Conceptual Review Agenda

Monday, June 6, 2016

CONCEPTUAL REVIEW: APPLICATION

Re: 2620 W Elizabeth St - Single-family Detached

CONCEPTUAL LOTTING PLAN OPTION 1

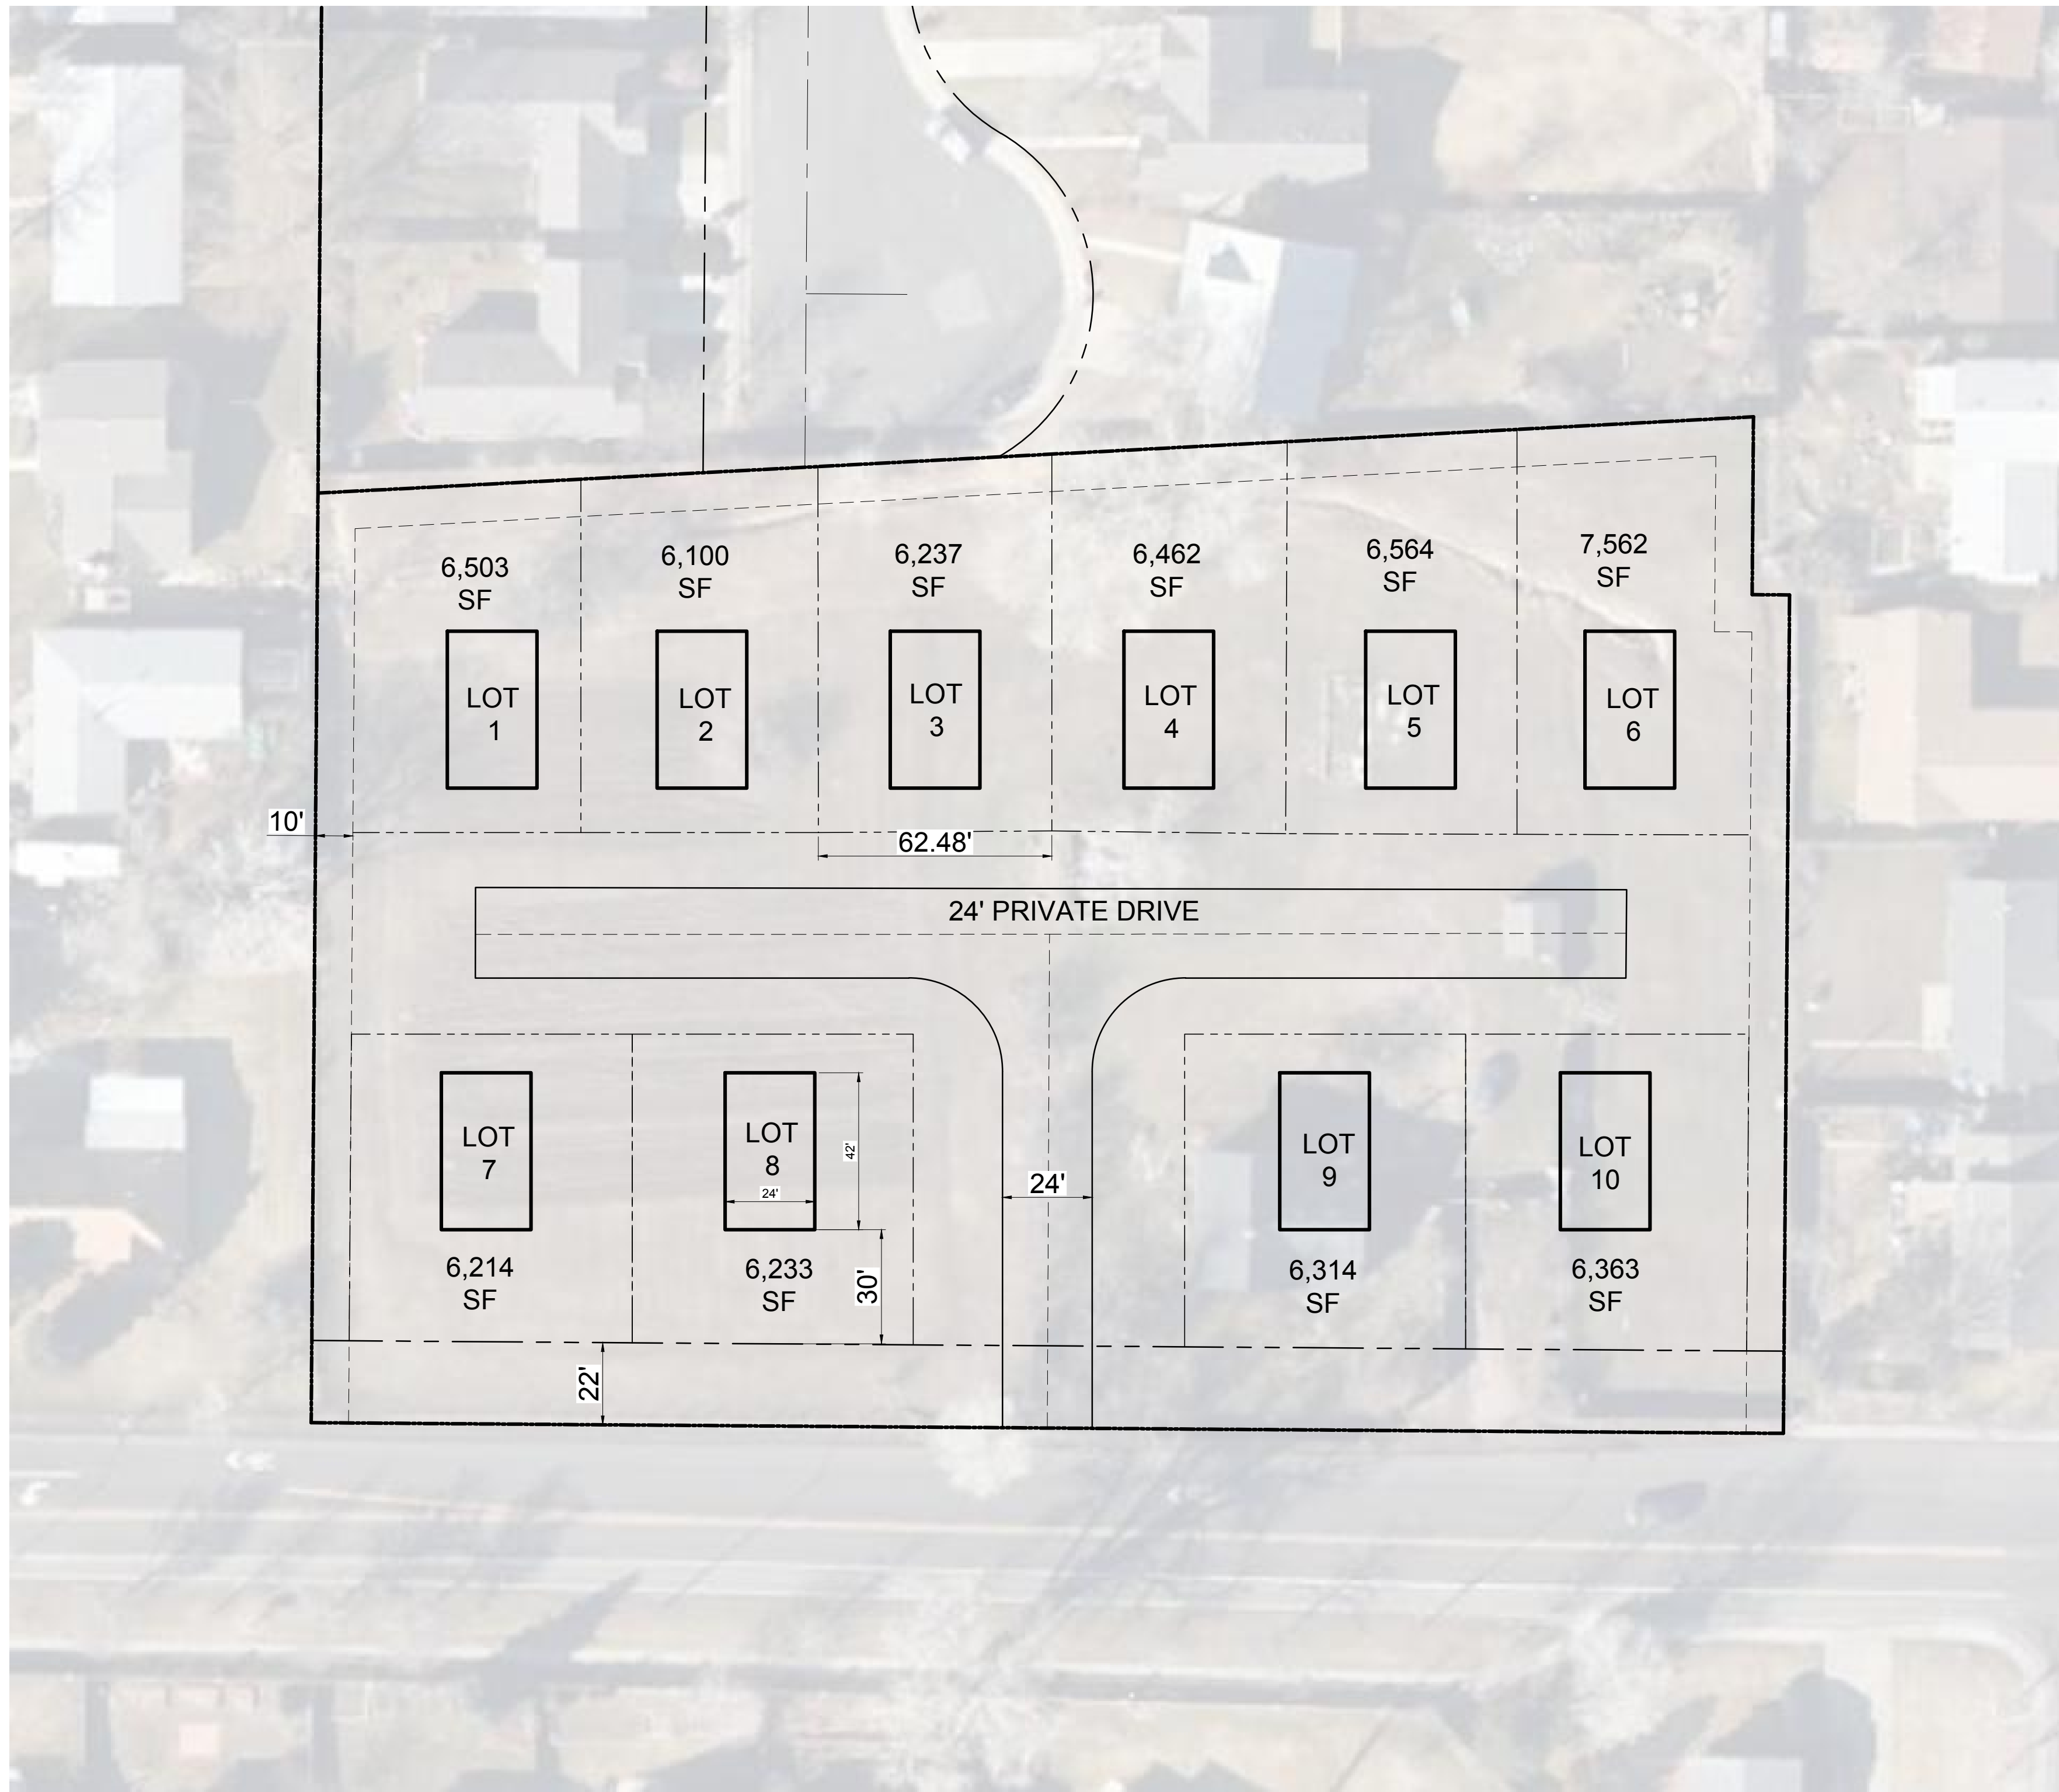
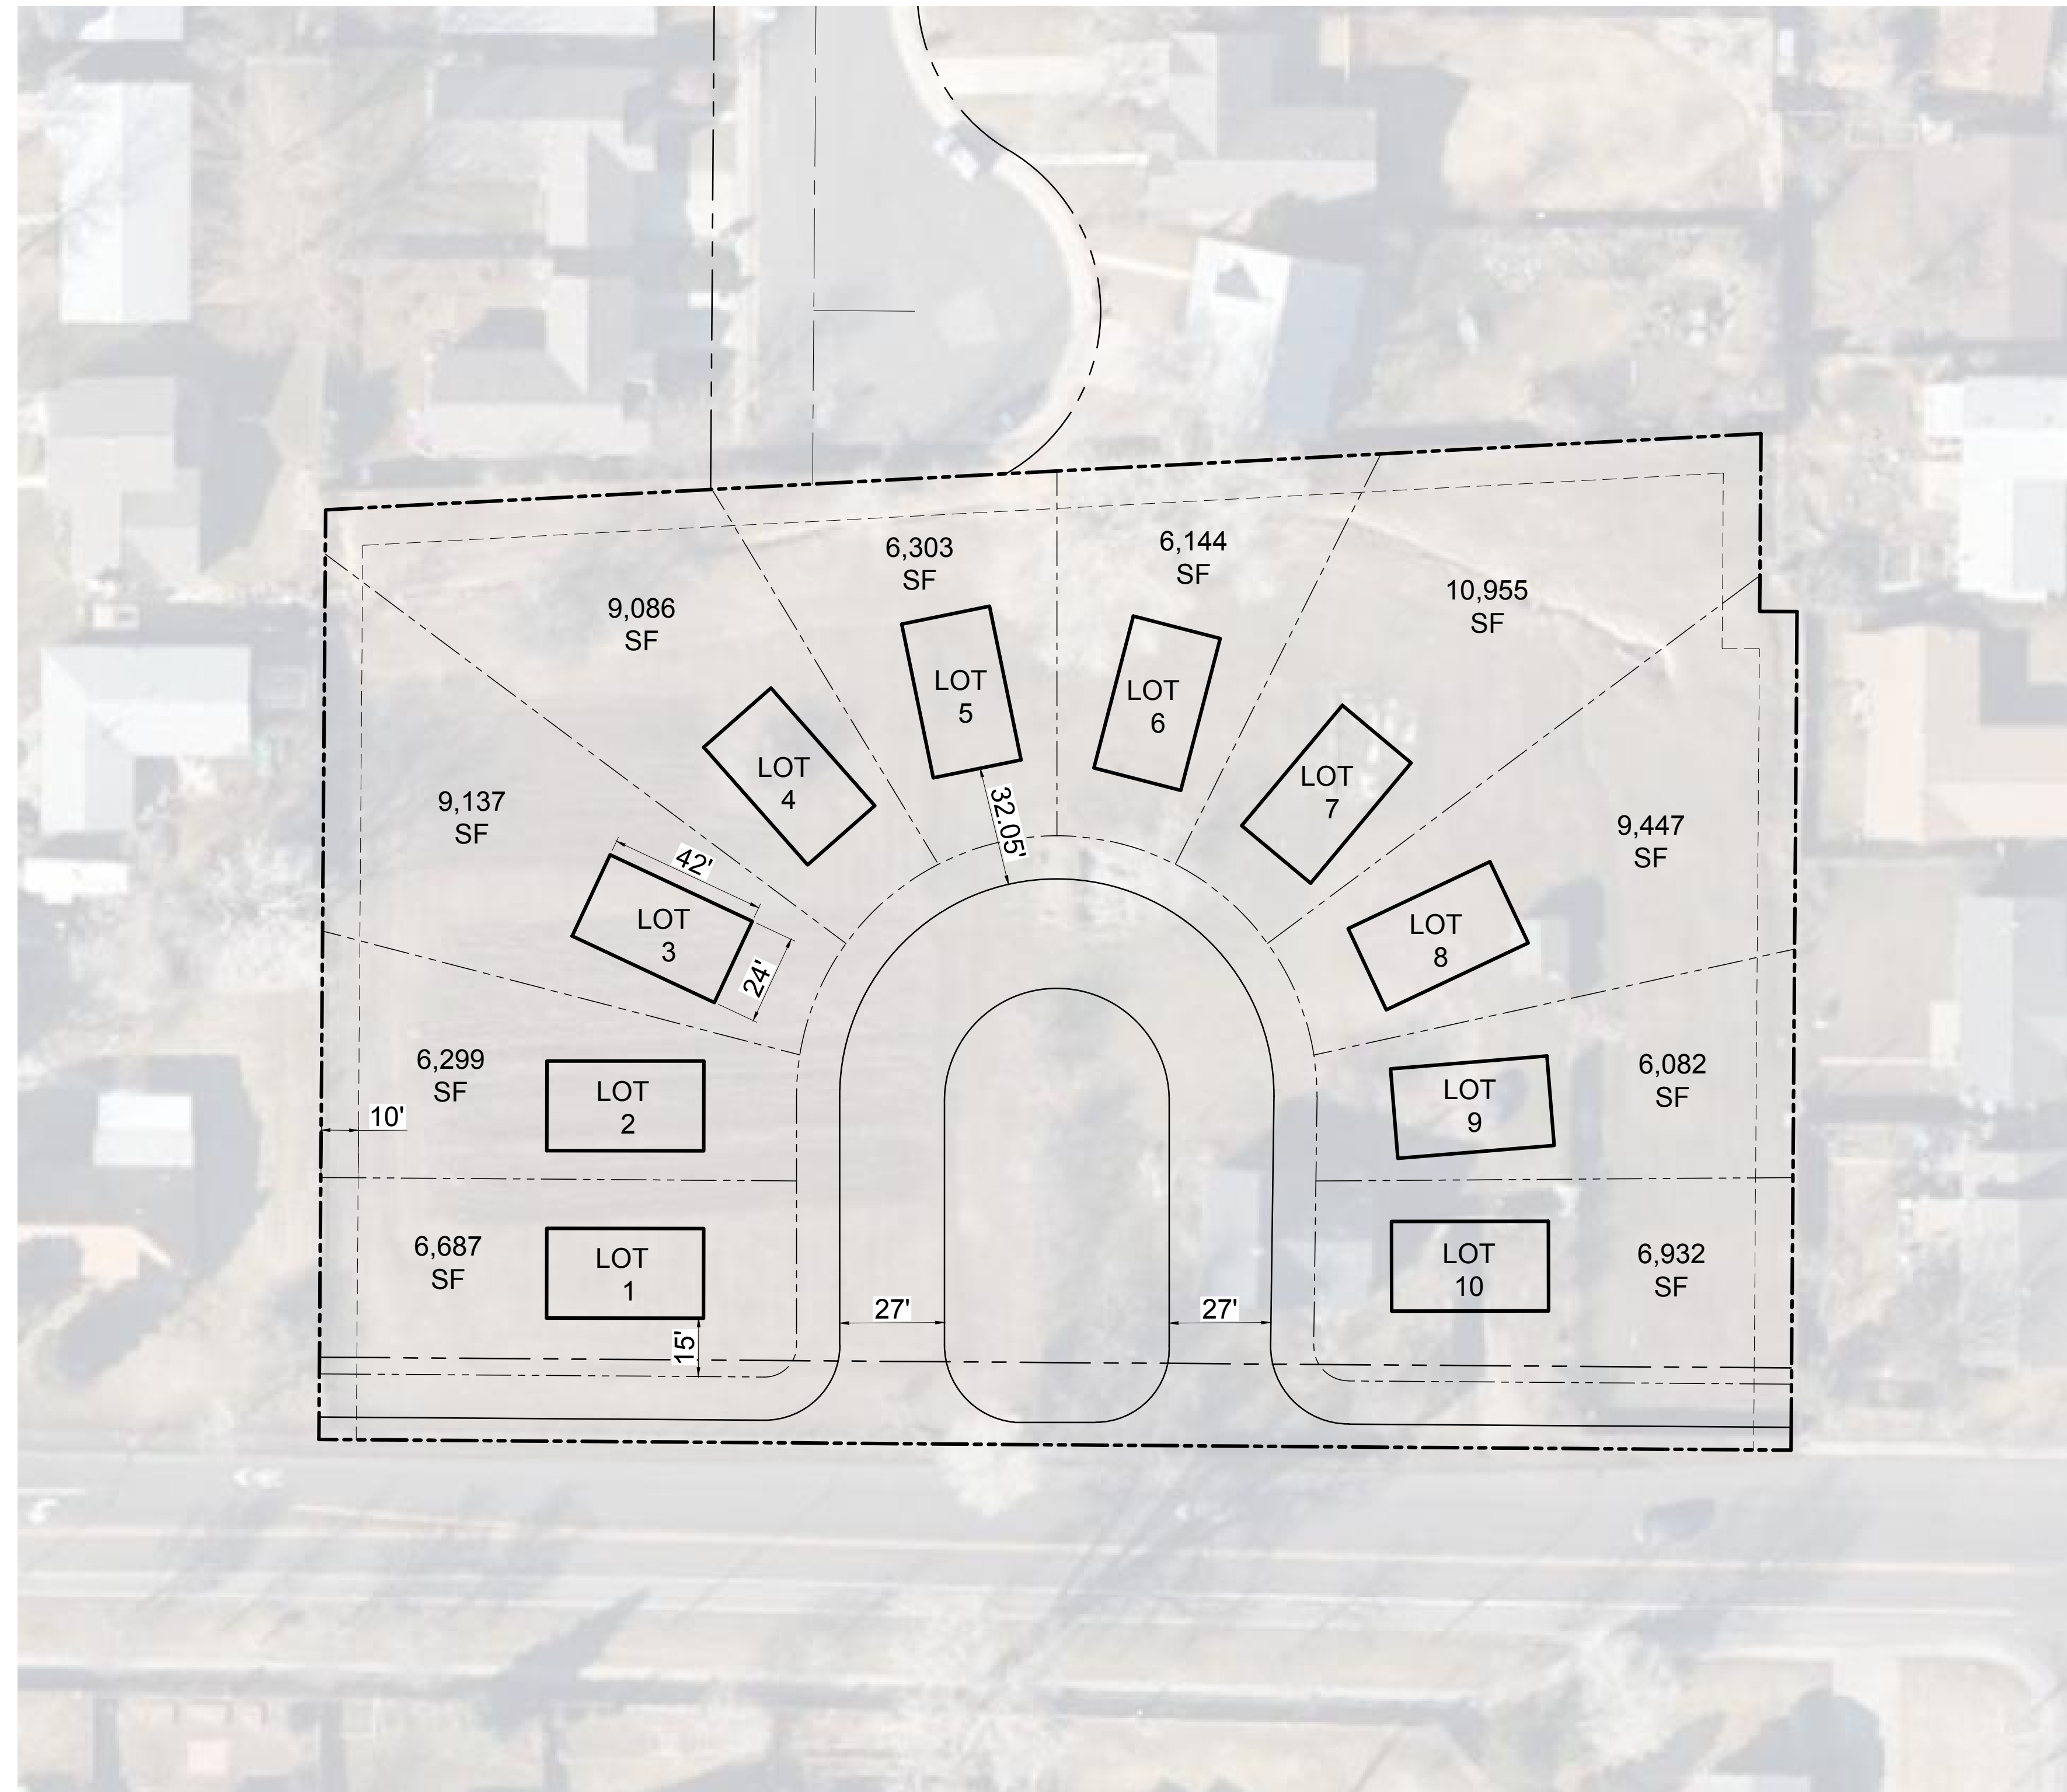
2. The proposed site plans, as shown, do not appear to allow for connection to the water and sewer mains in Pear Court. The sewer main in Pear Court is the only feasible connection point for this development. In addition, to adequately serve this site, a water main loop will be needed that connects the 6-inch main in Pear Court to the 12-inch main in Elizabeth.

1. Since Pear St is stubbed to the northern property line, Pear St should continue into the site with bike and pedestrian access provided to Elizabeth St.

2. There is a 6,000 sq. ft. lot size requirement minimum for single-family detached homes in the Low Density Residential zone district. If the lots have less than 6,000 sq. ft. a modification will be required. Staff would not likely support this modification request.

3. The maximum building height in the RL zone district is two stories. The three story buildings shown as part of the submittal package would require a modification.

SITE PLAN

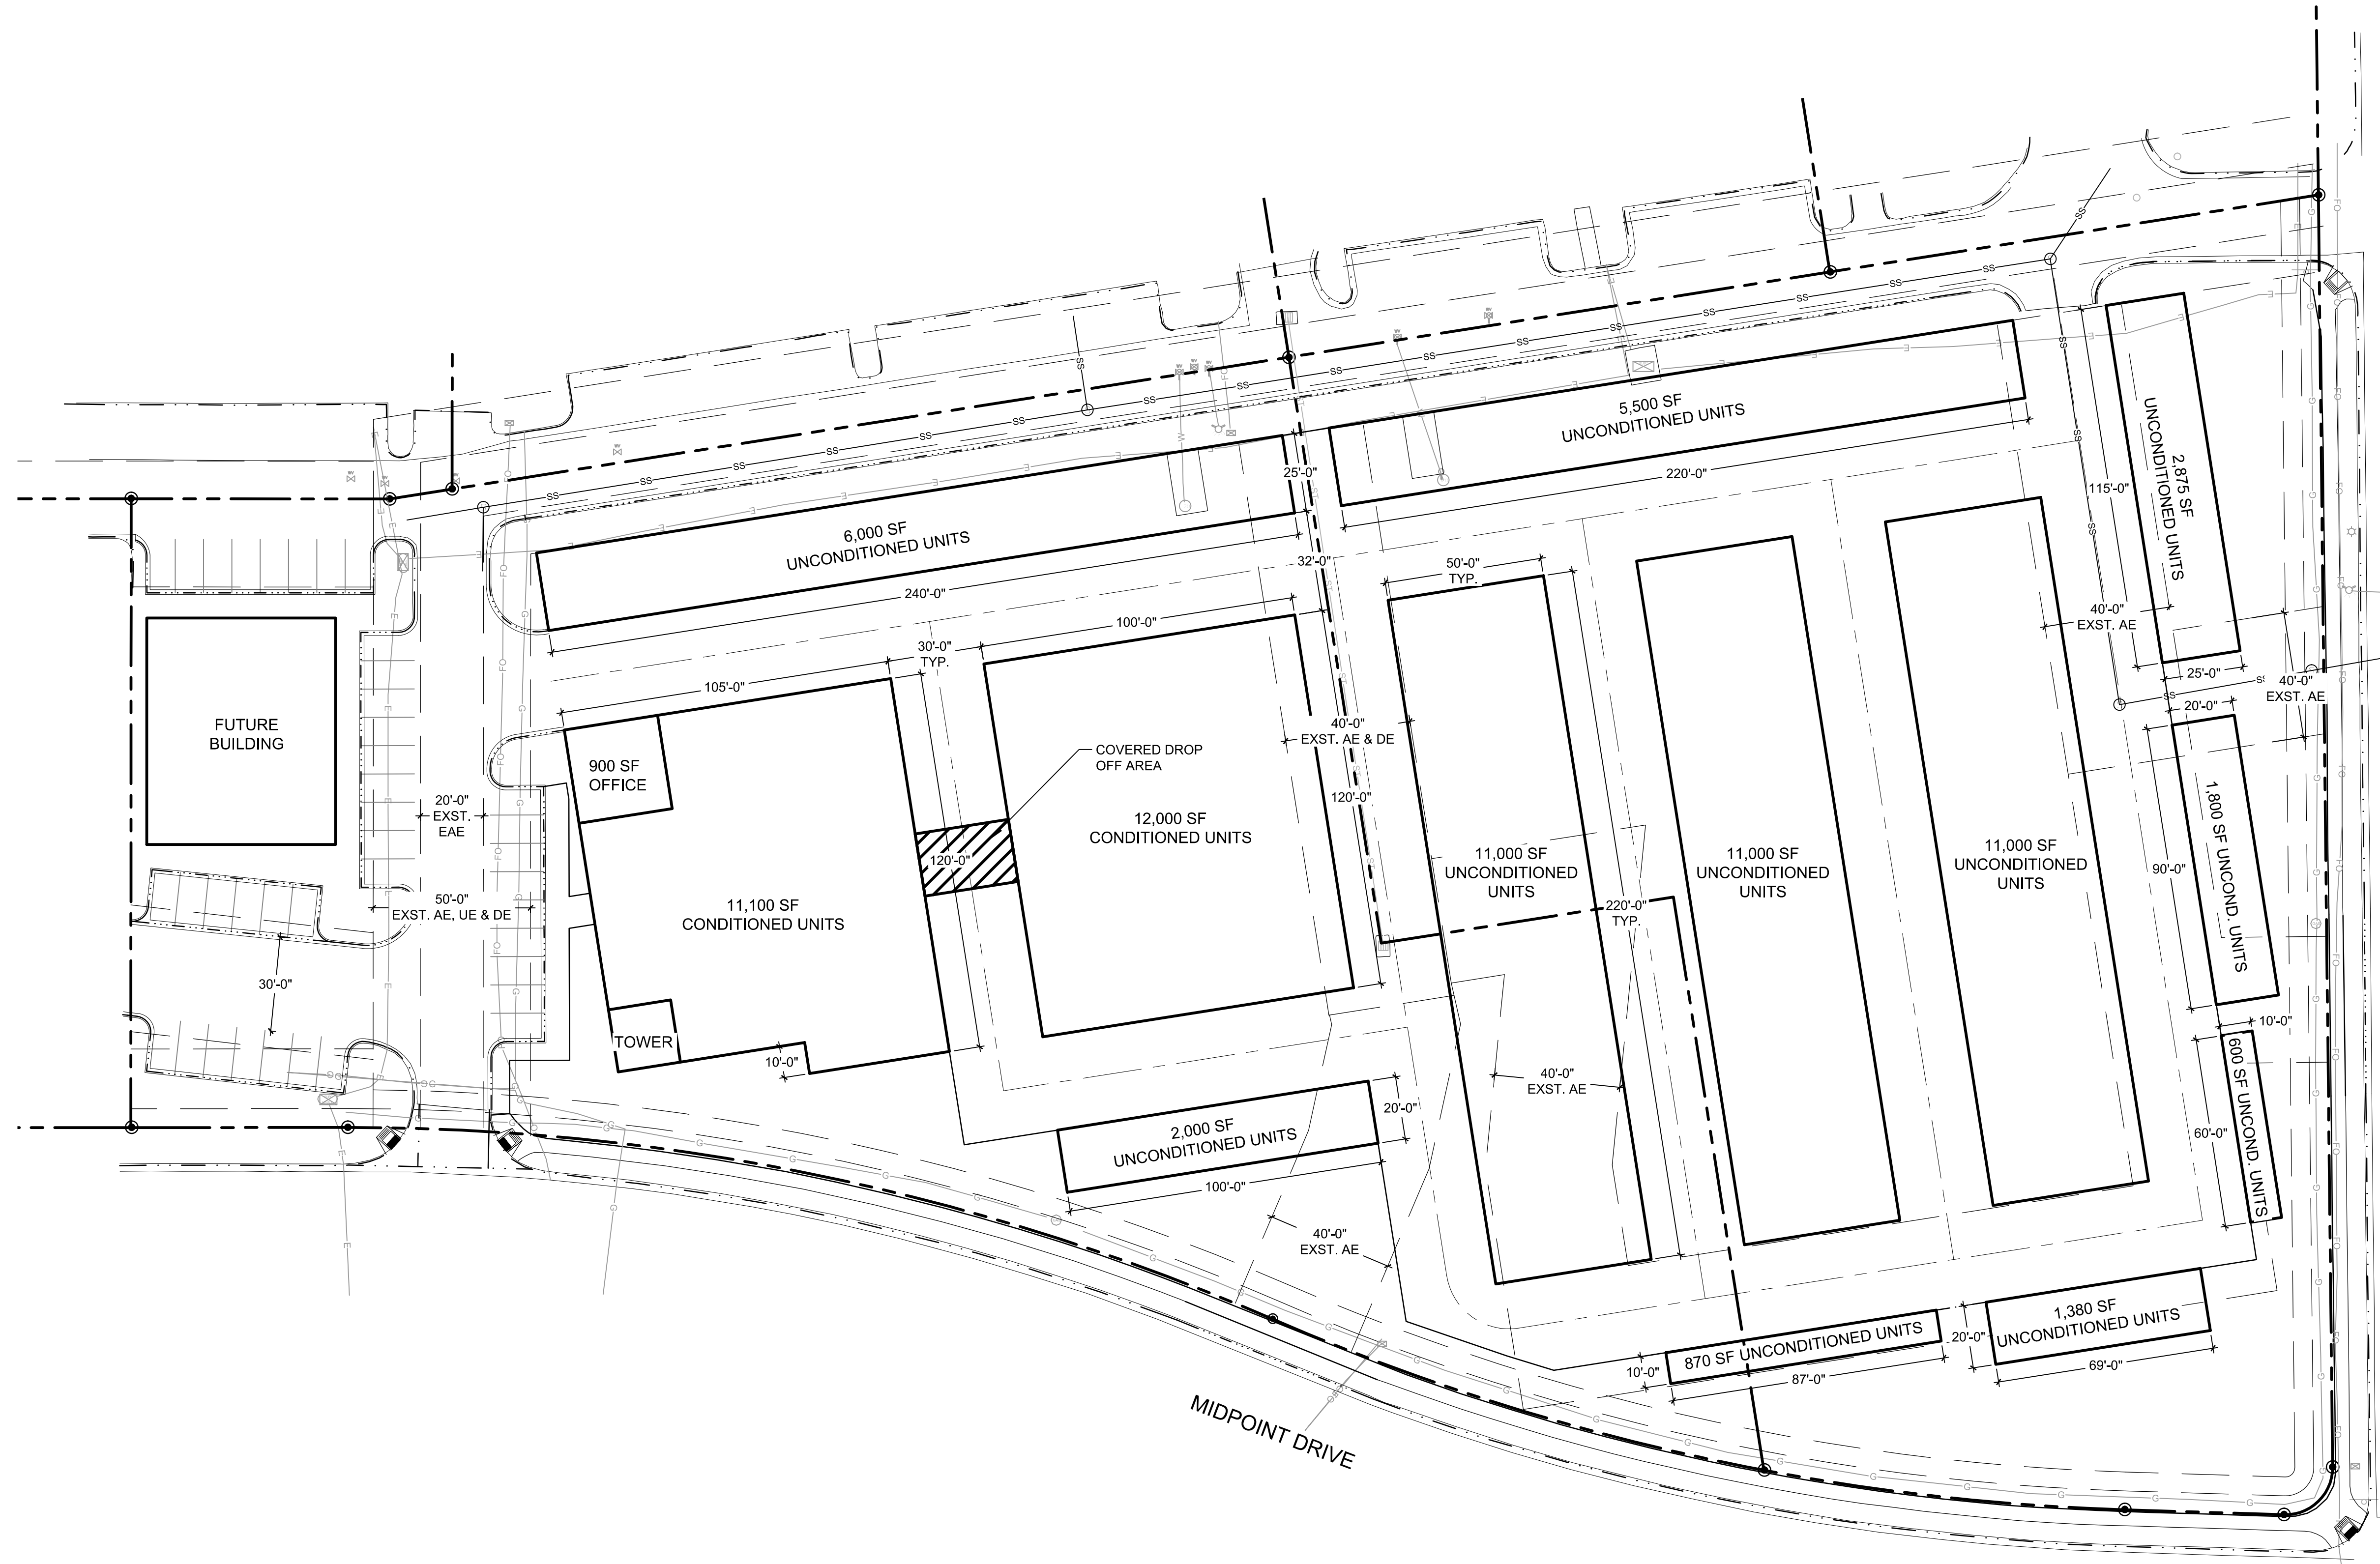
4. No bicycle parking is shown on the site plan. Four bicycle parking spaces are required for the storage facility. These can all be provided via fixed racks. For the future building, the bicycle parking required will depend on the use. Once staff knows what use will be proposed there, staff can provide an accurate bike parking count required.
